Subject: **FLASHING PICTURE OR IRREGULAR
 WHITE BALANCE**

Model: **BVM-8044QD, PVM-5041Q, PVM-8040
 PVM-8041Q, PVM-8043MD, PVM-8044Q**

Figure 1

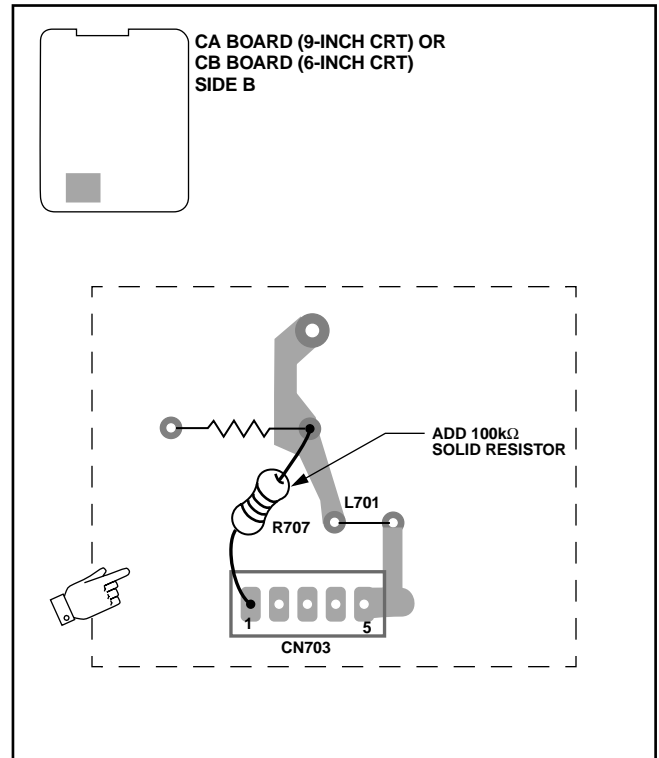
In some units, the picture may flash or white balance may become irregular. If this occurs, perform the following procedure.

**CA Board (9-inch CRT) or CB Board (6-inch CRT)
 Side B (See Figure 1.)**

1. Replace CRT.
2. Solder new 100kΩ solid resistor as shown.
